TECHNICAL SERVICE BULLETIN

Wind/Whistle Noise From Front A-Pillar Applique

22-2021
31 January 2022

Ford 2020-2022 Explorer
Lincoln 2020-2022 Aviator

Figure 1

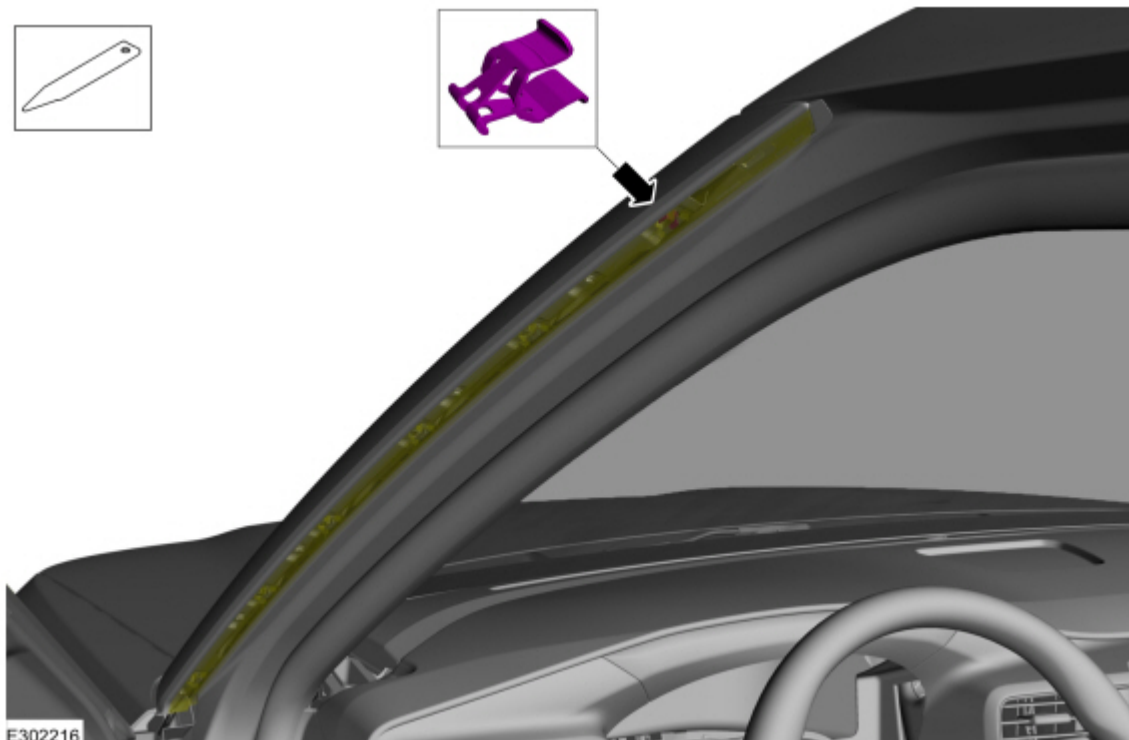
Issue: Some 2020-2022 Explorer/Aviator vehicles may exhibit a wind/whistle type noise at highway speeds originating from the front A-pillar applique (either side or both). This may be due to a small gap between the outboard side of the A-pillar applique and the moulding. To correct the condition, follow the Service Procedure to install thin strips of flock tape on the A-pillar applique.

1. Using a non-marring trim removal tool, remove the A-pillar applique. Refer to Workshop Manual (WSM), Section 501-08. (Figure 1)
